**Freightliner
Service Bulletin**

General Information

Fig. 1, Position of Pilot Bearing When Spacer Is Not Needed

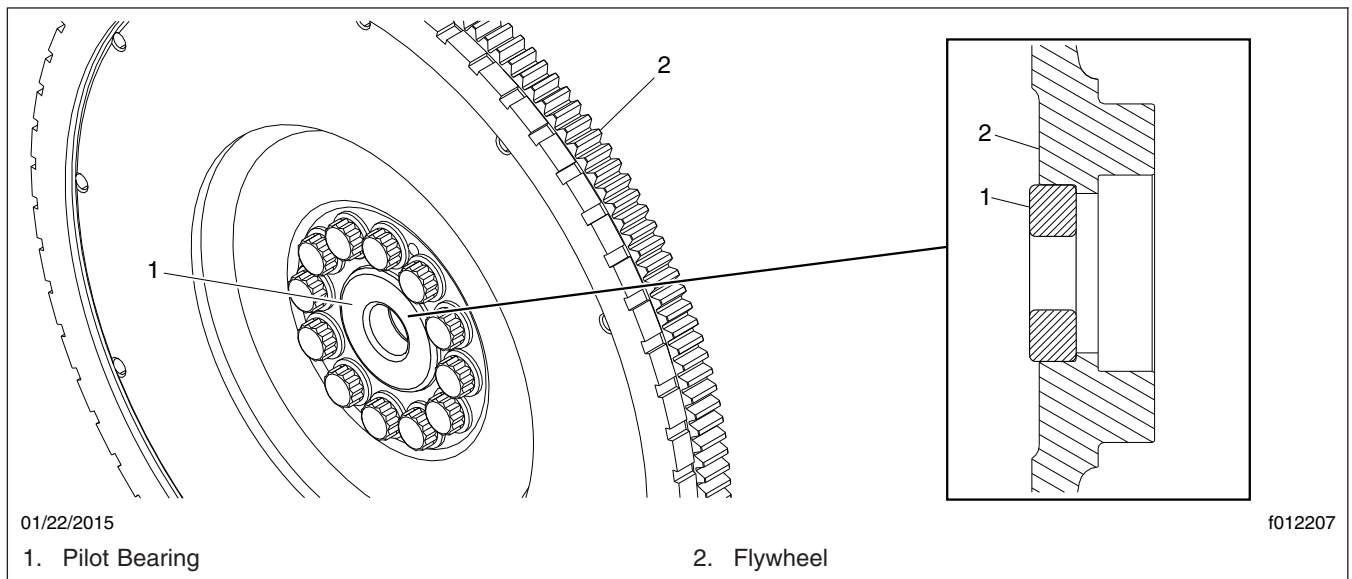
The input shaft on Eaton transmissions does not extend fully into the pilot bearing on DD-series engines built before March 5th, 2015. DD-series engines built on or after March 5th, 2015 have a revised flywheel with the pilot bearing positioned for full engagement with the input shaft.

On vehicles that do not have a pilot bearing spacer installed, the pilot bearing will be flush with the flywheel. On vehicles that already have the spacer, the bearing will protrude approximately 1/4 inch from the flywheel, as shown in [Figure 1](#).

A spacer, part number 02-14069-000, is now available to reposition the pilot bearing within the flywheel by the same amount as the revised flywheel.

If input shaft wear exceeds Eaton specifications for normal wear, replace both the input shaft and pilot bearing.
